**MM18/16 SECTION 75W MODIFICATION APPLICATION TO THE  
CONCEPT PLAN FOR A MIXED USE DEVELOPMENT -  
SHEPHERDS BAY MEADOWBANK - The Mayor,  
Councillor Bill Pickering**

# Shepherds Bay Redevelopment

## Modification request for Concept Plan MP 09\_216 and Project Application MP09\_219

**Submission from City of Ryde Council**

Indicative section of proposed Community Facility in Stage 9:

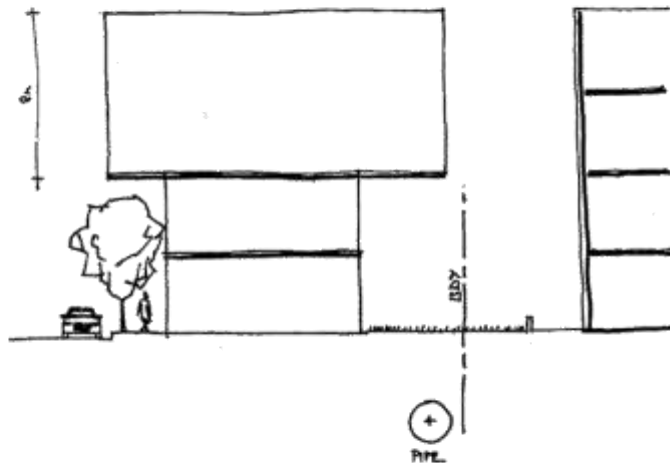
Despite applying to increase the number of dwellings the Modification application seeks to reduce the size of the community centre from 1000m<sup>2</sup> to 500m<sup>2</sup>. The application seeks to place the community centre within Stage 9, located over the subterranean gas pipeline. As a result of the clearance requirements for the pipeline and the floor to ceiling requirements for a multi-purpose community hall, the overall height for this community centre building (16m+), when combined with the proximity to the adjacent apartment building and consequent impacts, cannot be supported by

Council (indicative section provided below). As a result of these concerns Council proposes that this building is restricted to 1 storey maximum. As options put forward for the community centre have proved unsatisfactory, it is suggested that conditions of consent allow Council and the Developer to continue to work together to achieve a satisfactory solution.

Proposed Development Envelope – Stage 9:

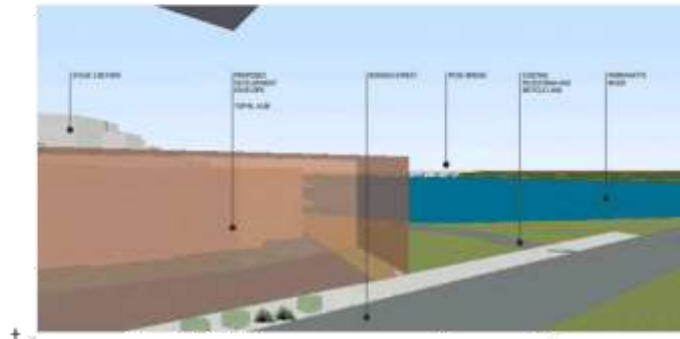
The proposed location of the community centre within stage 9 satisfies some of the abovementioned requirements. However, the proposed configuration and narrow floor plate does not support a broad range of community uses and the likely impacts on residents of 146 Bowden St cannot be supported.

- Objection is raised to the proposal to relocate the community facility to the stage 9 building on the basis of:
  - The overall height of the building will result in a negative impact on the residential apartment building under construction at 146 Bowden Street, overshadowing, views, outlook, ventilation and sunlight access.

Note: The community facility is to be approx. 8m floor to ceiling clearance to ensure flexibility for a range of uses and construction over the subterranean oil pipeline requires an 8m clearance resulting in a building over 16m tall – taller than the apartment building at 146 Bowden Street. Refer diagrams below – particularly the diagram bottom right.

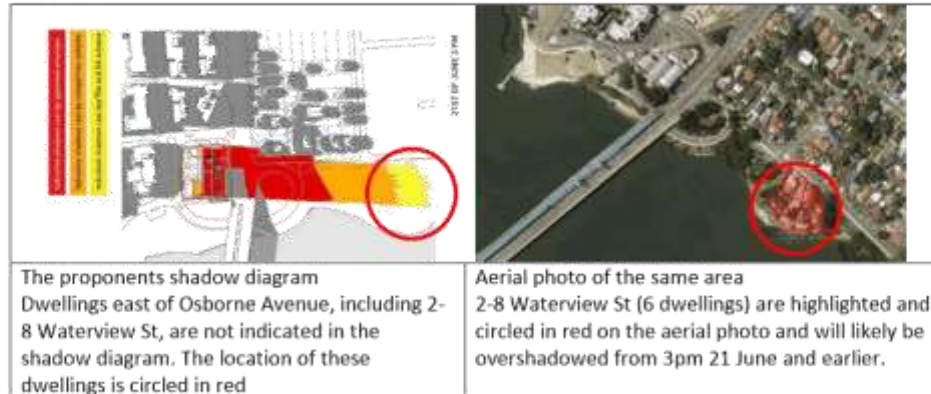
- The shadow diagrams are not correct and a complete assessment of the overshadowing impact cannot be made. However, it appears that the competition winning scheme and the further increases to the tower height will likely result in overshadowing to homes at 2-8 Waterview St from around 2.30pm onwards mid-winter. Objection is raised to this impact.

Note: The increased overshadowing is both on the public domain/sensitive foreshore and mangrove areas and probably on private homes east of Osborne Avenue at 2-8 Waterview St Putney. The shadow diagram for 3pm 21 June indicates that shadows extend appreciably east of Osborne Avenue but the diagram does not show the residential development in this area. This is illustrated in the below comparison of the proponent's shadow diagram and aerial photo. 2, 2A, 4, 6, 6A and 8 Waterview St sites are highlighted on the aerial photo.

- The shadow diagrams for 21 June need to be accurately updated in order to make a proper assessment of the impact of overshadowing as a result of the additional height. The residents of 2-8 Waterview St should have further opportunity to comment on the impacts upon the preparation of accurate shadow diagrams.
- It is noted that the competition scheme at 19 storeys is preferable in terms of overshadowing impacts to the proposed 24 storey tower.

**Figure 1 – Parsonage Street / Well Street / Porter Street Preferred Configuration**

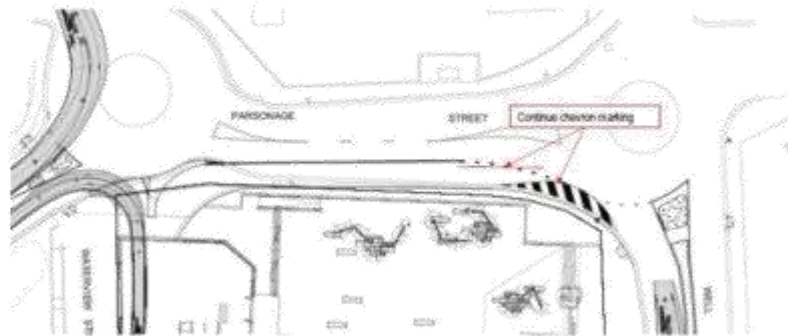
- The proposed access arrangement immediately south of the Parsonage/Well/Porter Street roundabout provides opportunities for unnecessary weaving, introducing potential operational and safety issues. It is recommended to maintain a single southbound lane

departure from this roundabout prior to developing the access left turn lane (refer to **Figure 1** below).

**Figure 3**

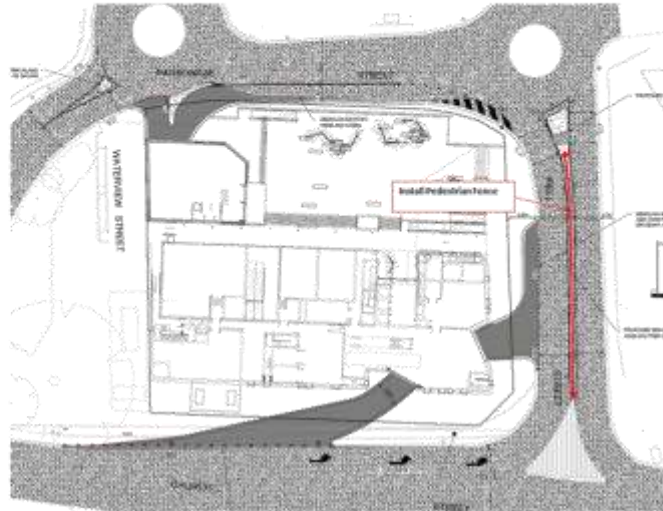
- Undertake a Stage 1 Road Safety Audit of the access intersection configuration/ existing roundabouts.
- It is noted that 900mm wide splitter island in Well Street will be extended to the pedestrian refuge. It is recommended that the pedestrian fence be installed to prevent pedestrians from walking across Well Street and to encourage using the proposed pedestrian refuge (refer to **Figure 3** below). It is recommended that the provision of these works be conditioned in any consent.
